MEETING AGENDA OF THE CLEARFIELD CITY PLANNING COMMISSION

STAFF REPORT

SUBJECT: Discussion and Possible Action on **CUP 1905-007**, a conditional use permit request by Brad Carter with NovaSource Sunwest, LLC to construct a Valvoline Instant Oil Change center at the subject property. **Location:** 856 West Antelope Drive (TIN: 12-667-0024). **Parcel Area:** 0.41 Acres. **Zone:** C-2 (Commercial). **Planner:** Brad McIlrath (**Administrative Matter**).

ARCHITECTURAL
SITE PLAN

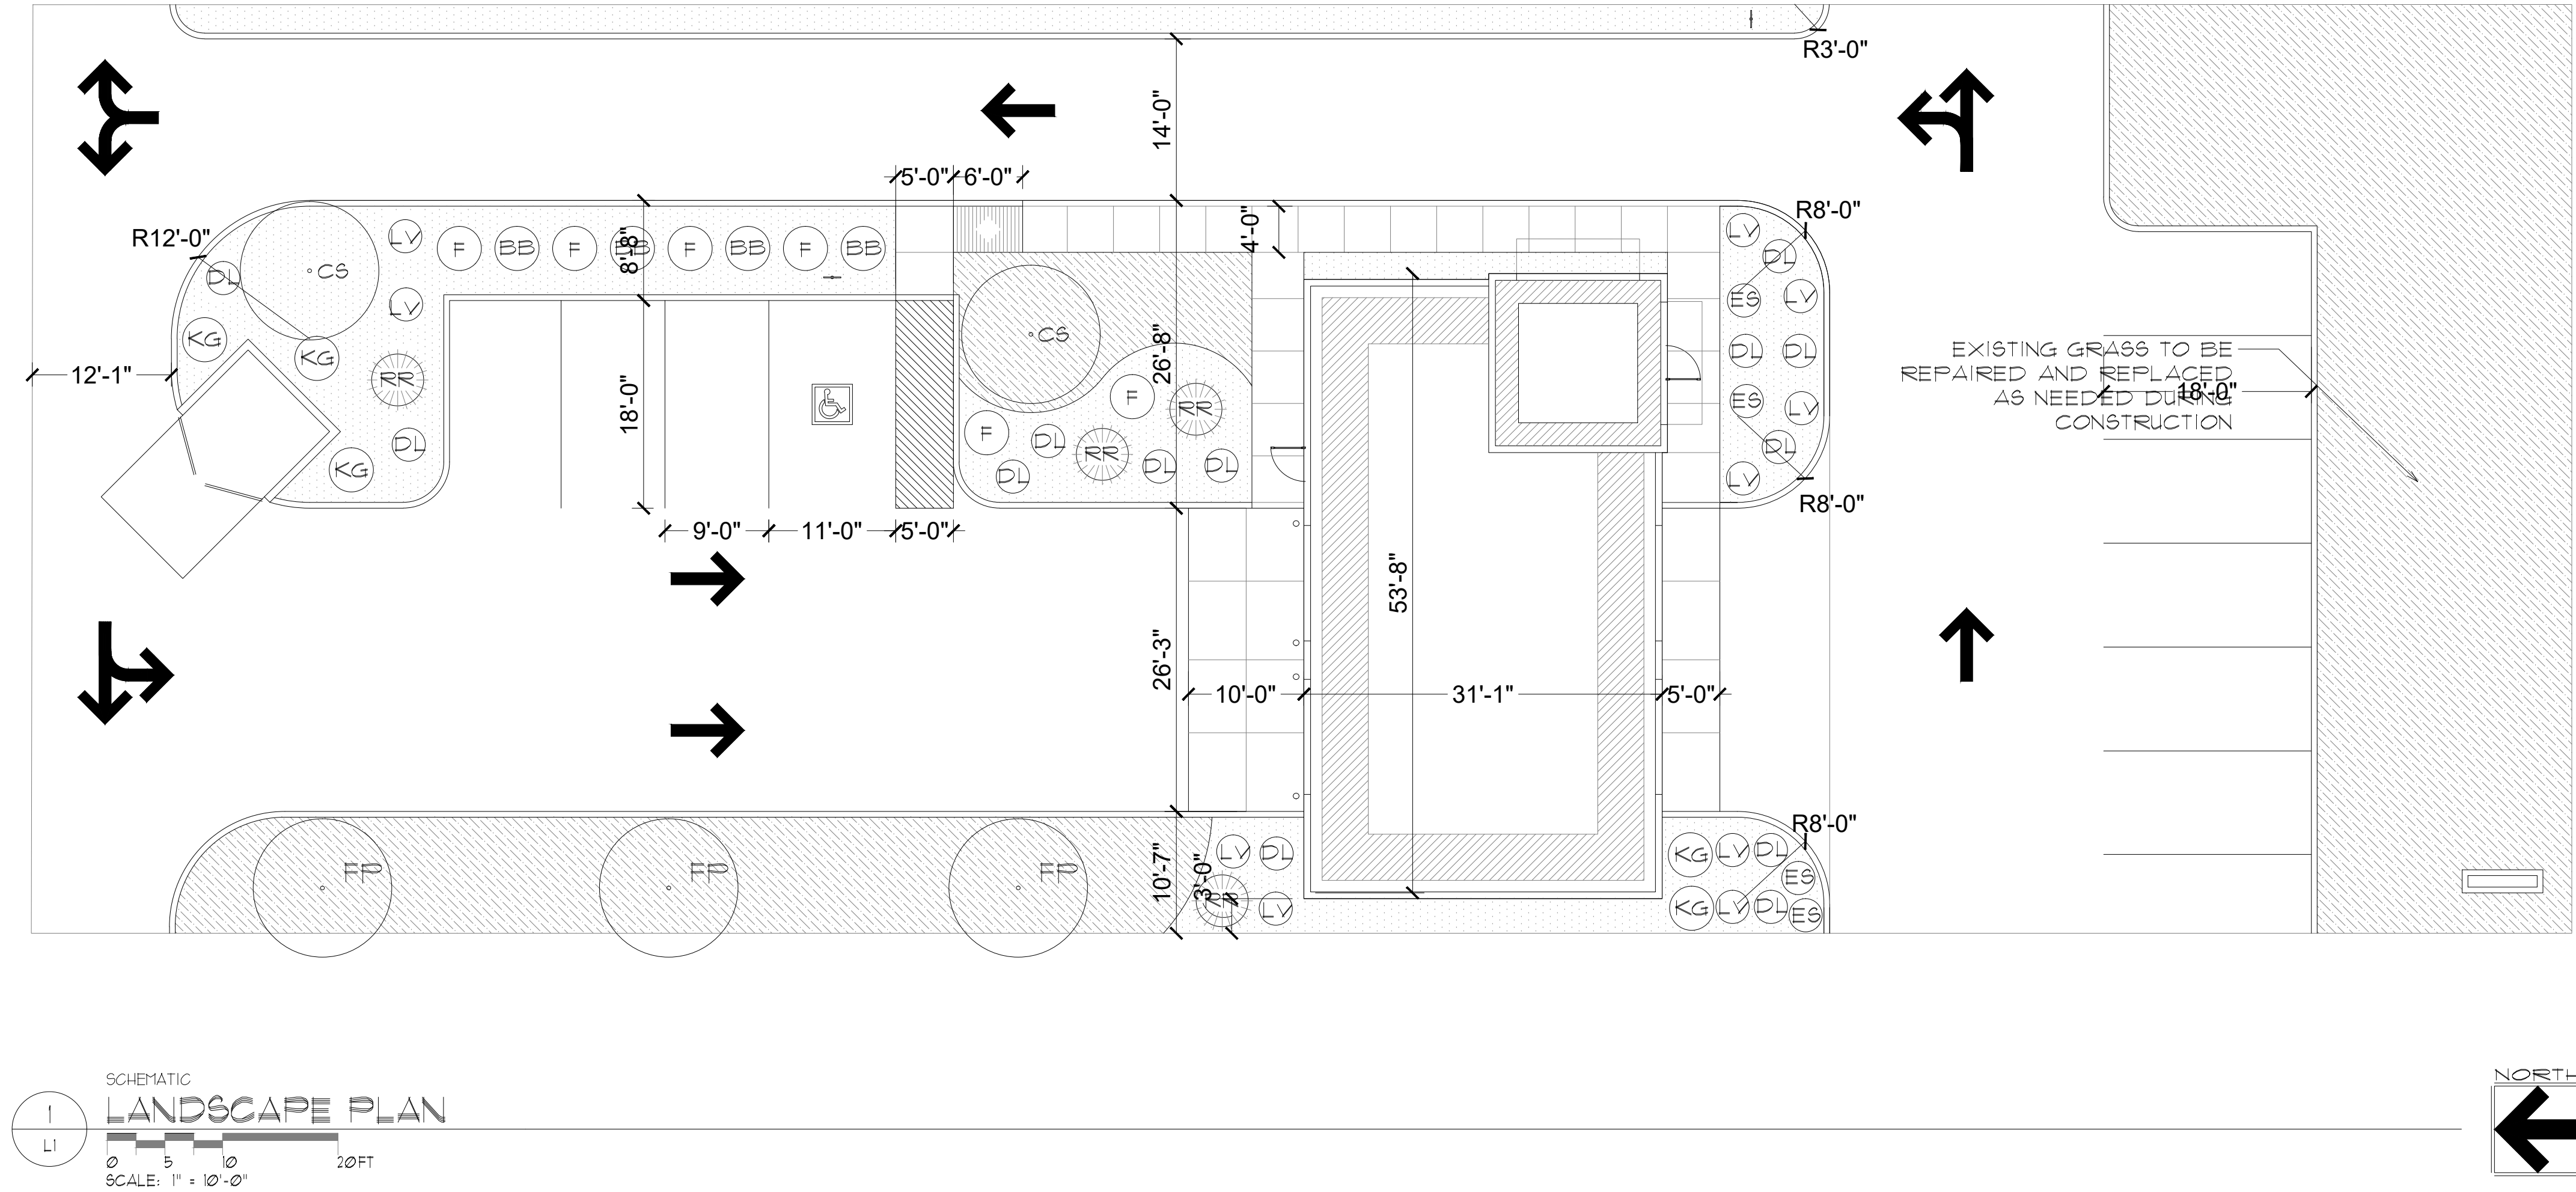
Chapter 11-14 “Off Street Parking and Loading” and 11-18 “Design Standards” outline the development standards for site access and parking for properties located in the C-2 Zone. Based upon the nature of this type of use, very little parking spaces are needed for customers. Clearfield City code does not include a parking standard for this type of use. Based upon standards identified by the American Planning Association in the Planning Advisory Service report 510 “Parking Standards” staff determines that the ten (10) parking spaces provided for this use is sufficient. The ADA parking space will need to be revised to include an eight foot (8’) wide access aisle to comply with federal standards.

As required by chapter 11-18, the site will need to be designed to provide a pedestrian access from the public sidewalk along Antelope Drive. As outlined in that chapter, this pedestrian access will need to be a minimum of five feet (5’) wide and be constructed of a different material than the parking lot as to be more identifiable. The proposed site plan includes a five foot (5’) wide pedestrian access to the sidewalk with striping for the walkway across the parking lot. The walkway across the parking lot will need to be constructed of a different material than the parking lot as listed above.

The proposed site plans shows a dumpster enclosure located at the north end of the property. To comply with ordinance standards, the enclosure shall be screened so the dumpsters cannot be seen by the public right-of-way. The enclosures must be constructed out of materials that match the building material or approved masonry enclosure.

- 3) The dumpster enclosure shall be constructed of the same material that matches the building or an approved masonry.
- 4) The access aisle for the ADA parking space shall be increased to eight feet (8') wide to meet federal standards.

- 5) The pedestrian path across the parking lot shall be constructed of a separate material then the parking as required by ordinance.
- 6) The front building façade materials shall be revised to comply with the approved materials outlined in the C-2 zone.

LANDSCAPE PLAN

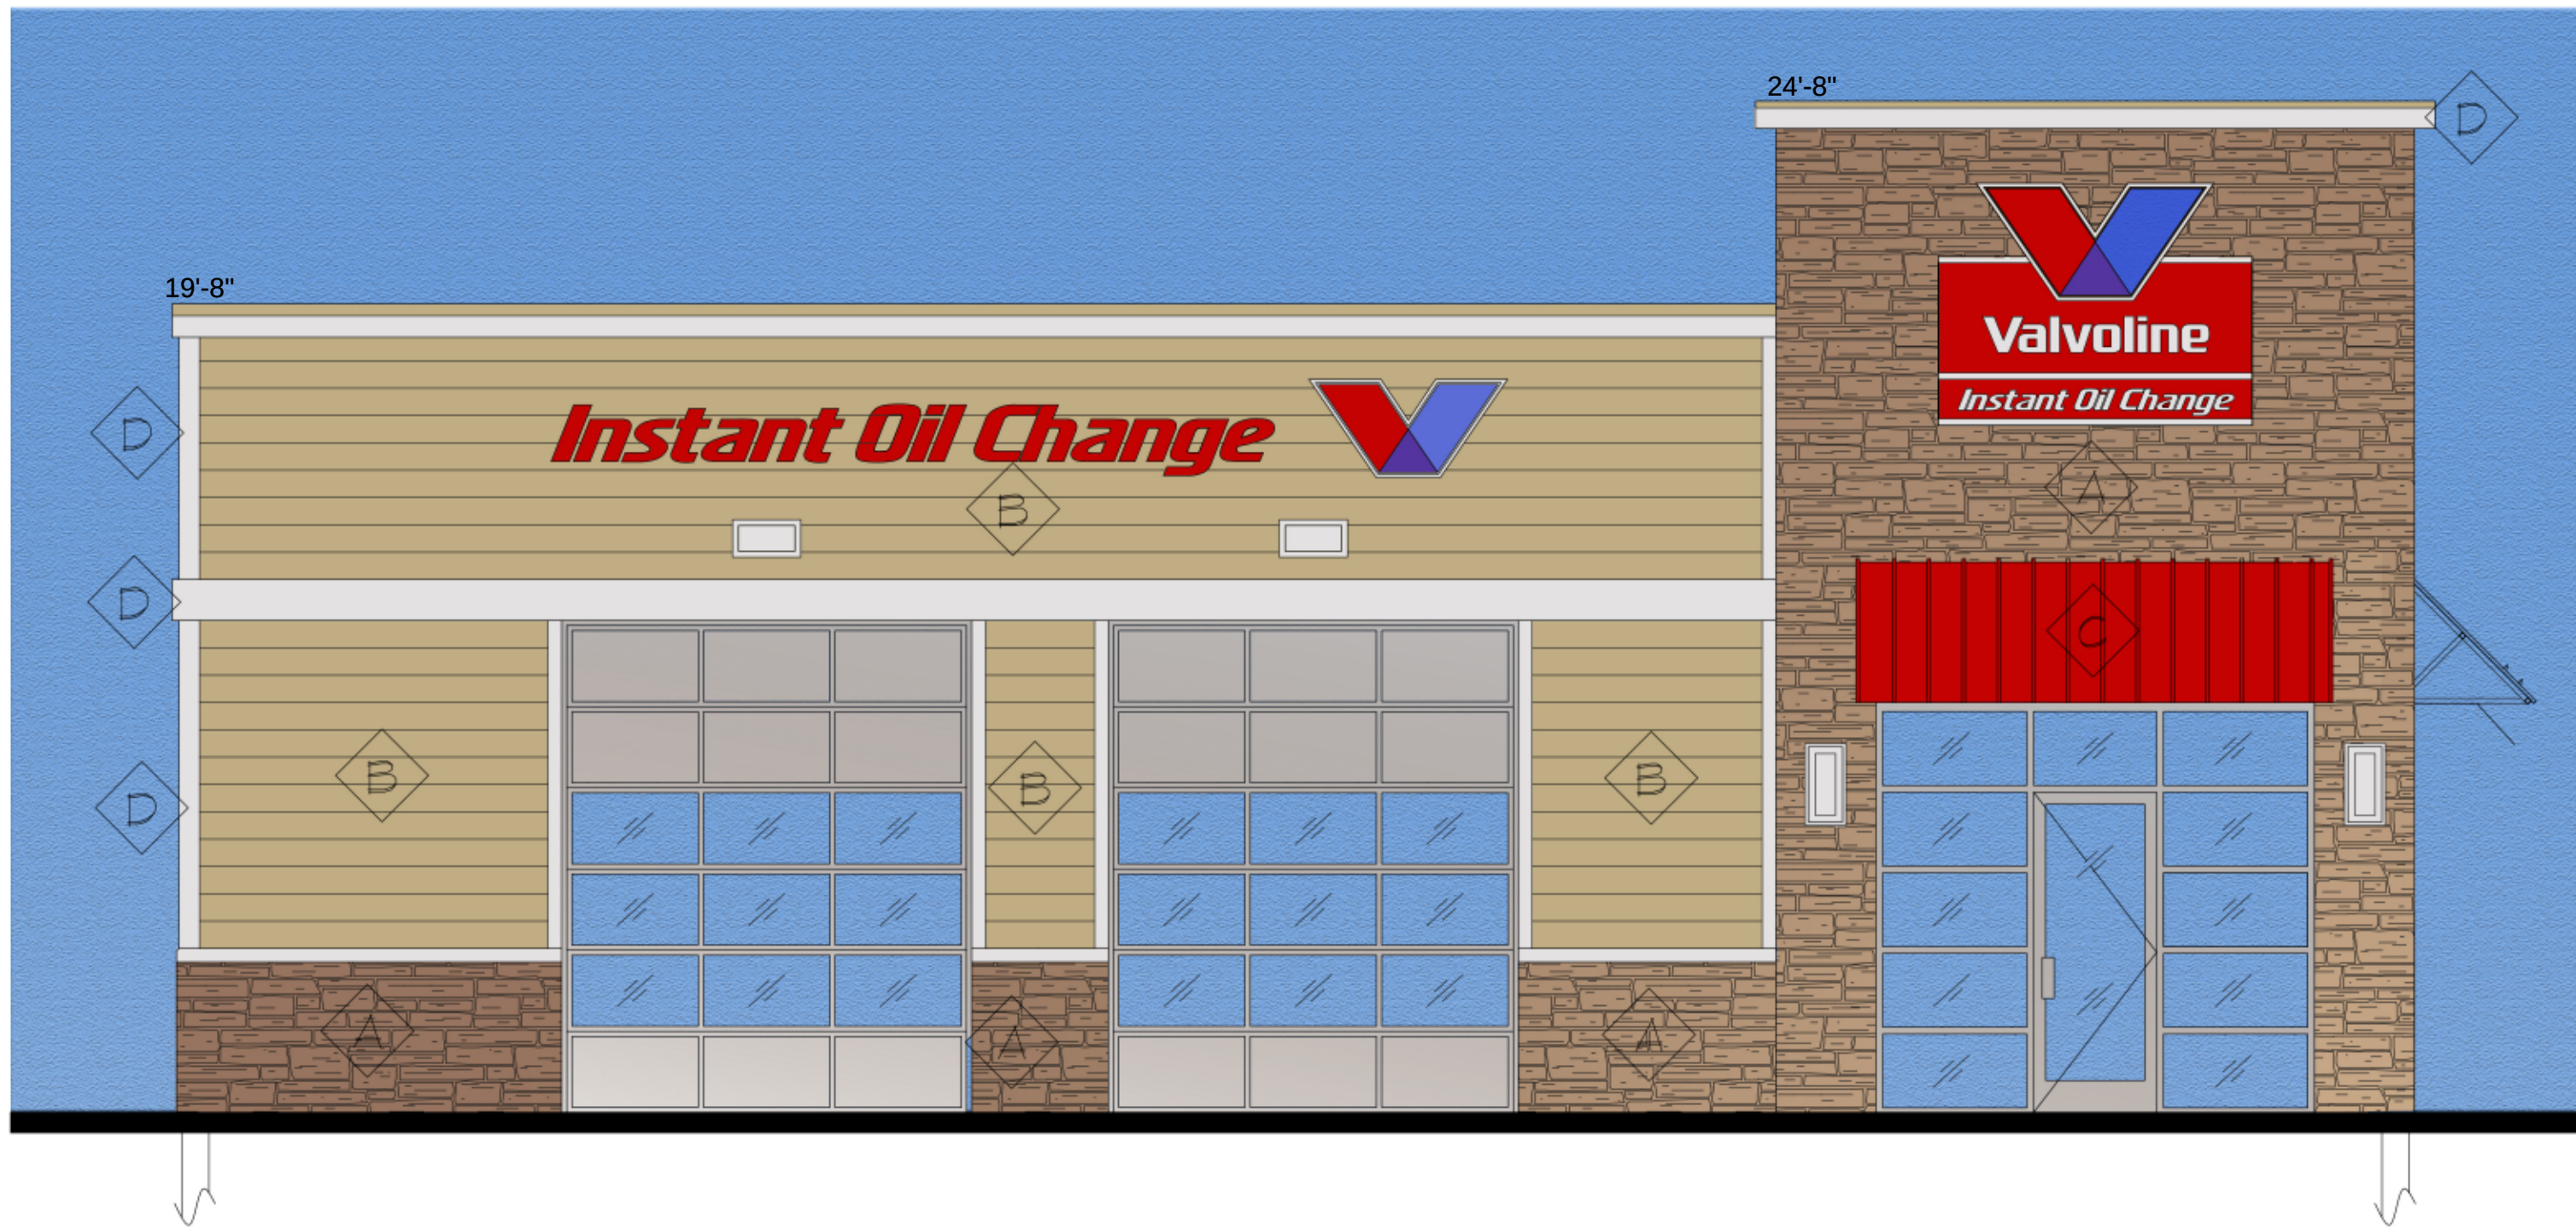
The C-2 Zone requires that a minimum of 10% of the total lot or parcel area be provided as landscaped open space. Based upon the submitted site plan 4,992 square feet or 23% of the site is provided with landscaping. As required by Section 11-13-23, landscape areas must include one (1) tree for every 500 square feet and one (1) shrub for every 300 square feet of landscaped area. Based upon these standards the site is required to include ten (10) trees and seventeen (17) shrubs. The proposed landscape plan provides nine (9) trees and forty one (41) shrubs. The landscape plan will need to be revised to include one (1) additional tree. All trees and shrubs that are planted must meet the planting standards outlined in Section 11-13-23 of the Land Use Ordinance.

Section 11-14-5F outlines standards for parking lot landscaping. When single row of parking is provided, there must be at least one (1) island for every twelve (12) spaces and must include one deciduous tree. This site includes a landscape island on the east end of the property. This island will need to be provided with one (1) deciduous tree as required by code and must include additional shrubbery and ground cover. As required by this code section, parking areas that abut a front yard or road frontage landscape area are required to be screened with a landscape hedge not less than three feet (3’) in height. The plant materials in this area must be evergreen species, have a minimum size of five (5) gallons and spaced no farther than five feet (5’) apart on center. The hedge must be set back a minimum of three feet (3’) and a maximum of six feet (6’) from the perimeter of any parking space.

In accordance with landscaping standards outlined in Chapter 18 (Design Standards), “drought resistant shrubs and trees are encouraged wherever possible in conjunction with efficient low water use irrigation systems.” As a guide to determine if this landscape design is utilizing drought tolerant or resistant plants, staff recommends that the applicant refer to the list found at www.waterwiseplants.utah.gov and replace the proposed materials with those found on that list.

- a. One additional deciduous tree shall be added to the landscape island at the east end of the front row of parking island. Shrubbery shall be added to the island as required by code.

- b. The front landscaping area between Antelope Drive and the parking area shall be modified to include a planting hedge to screen the parking area as required by ordinance.
